Architectural Review Board Meeting Agenda

1. Project: Nystrom Exterior Changes, Project 24-2283-ARB
Address: 1477 Manzanita Street
Applicant: Gordon Statler, agent for Eric Nystrom
Planner: Brian Banks

2. Project: Lagunitas Apts. & Mixed-Use Project, Project 23-2243-CUP/TPM/CDP
Address: 6380 Via Real
Applicant: Troy White, agent, for Steve Leonard, Manager, RPG Carpinteria, LLC
Planner: Syndi Souter

Project: 23-2243-CUP/TPM/CDP **Planner:** Syndi Souter
Address: 6380 Via Real
APN: 001-190-097
Zoning: M-RP
Applicant: Troy White, agent, for Steve Leonard, Manager, RPG Carpinteria, LLC

C-2.13 **SITE SECTIONS**

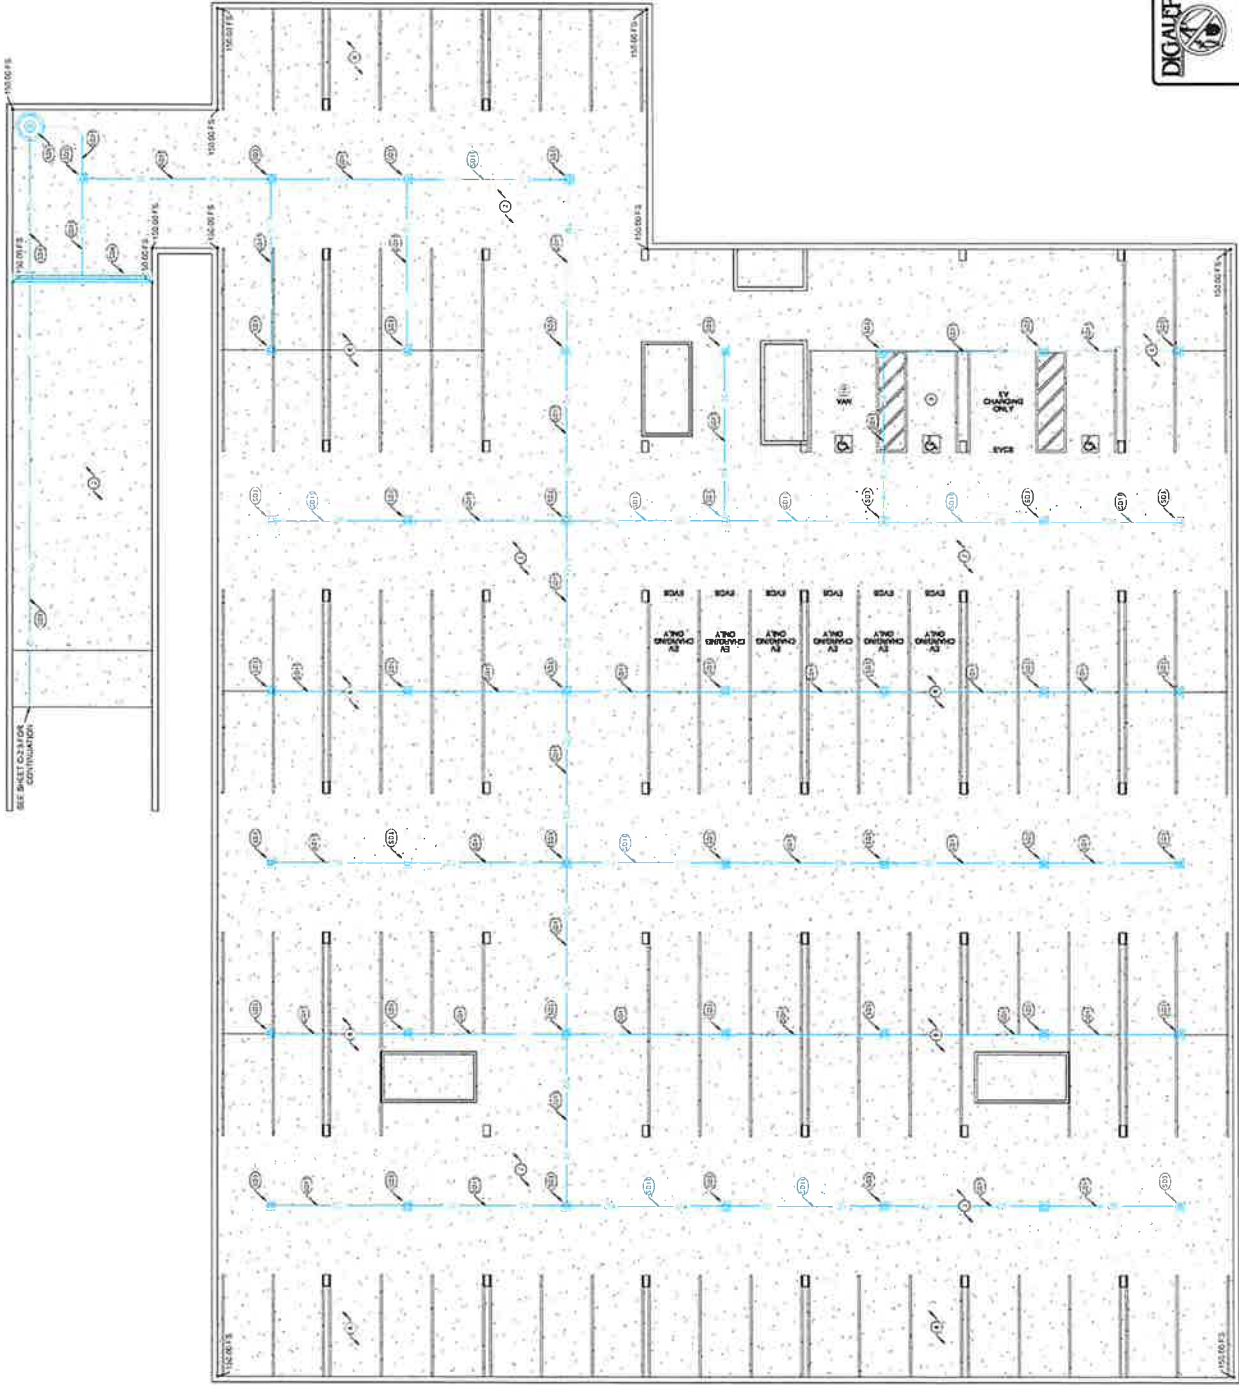
Additionally, the project plans indicate that approximately four-feet of fill will be placed over the project site to raise the elevation of the entire development (see Sheet C-2.13). Including the excavation for the underground parking garage, the project would require approximately 11,810 cubic yards of cut and 28,710 cubic yards of fill, resulting in the import of approximately 16,900 cubic yards of soil to the project site. The placement of the fill will add additional perceived height to the proposed structures in comparison to the existing site elevations. **The Board should review the proposed grading plan and comment as to whether the grading has been “minimized.”**

Sheet Title:
CONCEPT LIGHTING
EXT. ELEVATION -
BUILDING 1

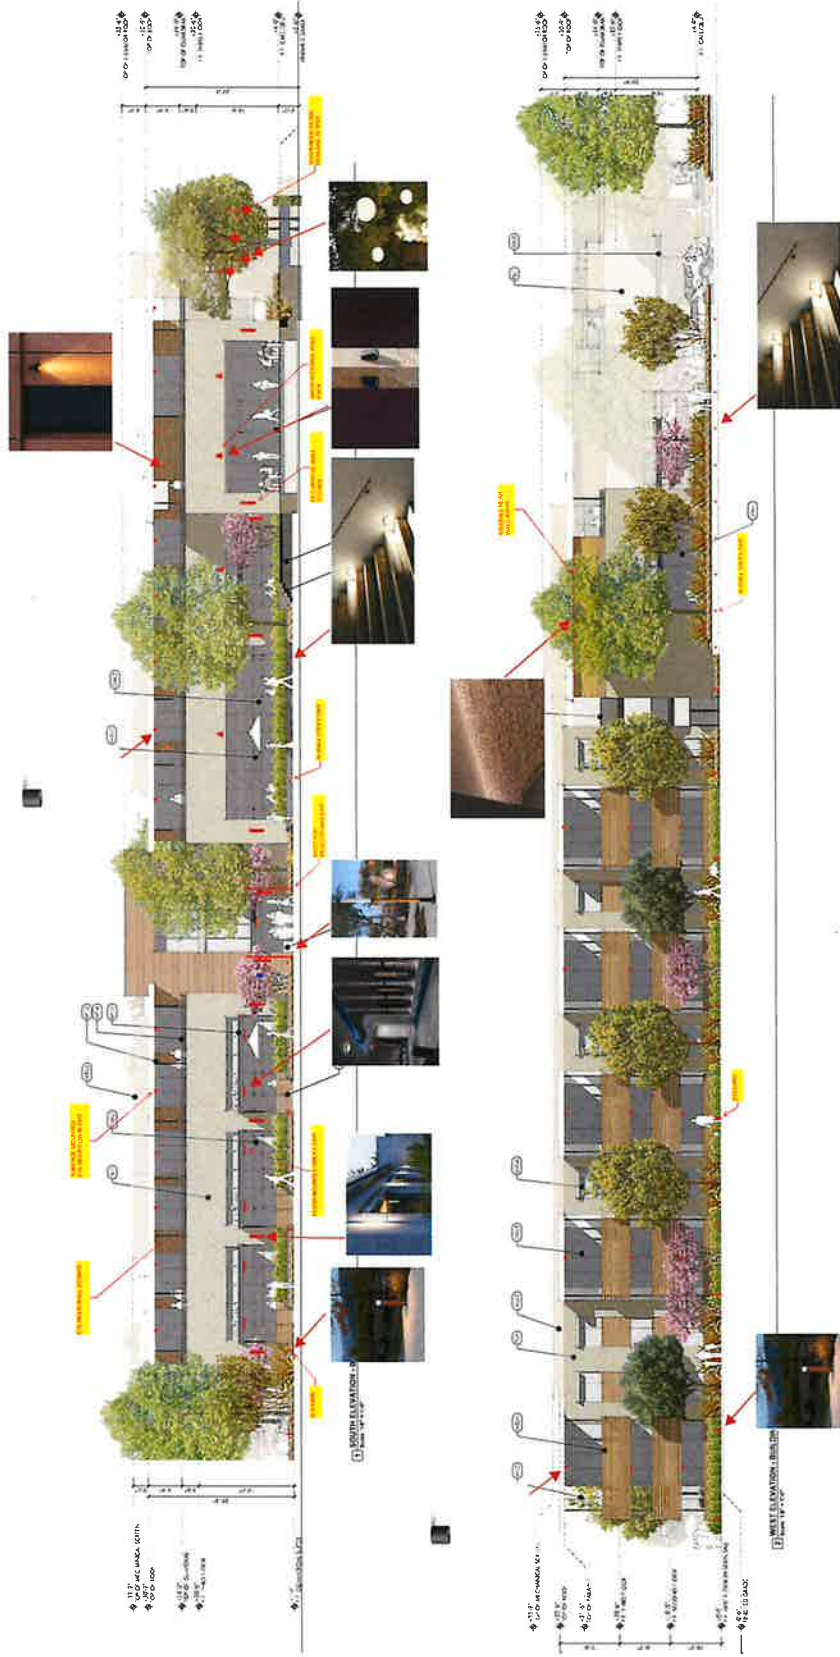
The project includes new exterior lighting. The fixture types and locations are shown on Sheets LT.1.0 through LT.6.0 of the plans in Attachment A, and the cut sheets are included in Attachment D. The proposed globe pendants suspended in the trees in front of the market/café provide a charming effect and likely meet the lighting objective. However, the proposed up-lights for trees in other locations do not appear to be night-sky friendly. **The Board should review the proposed exterior light fixtures and provide comments on their consistency with this objective and policy, including night-sky compliance.**
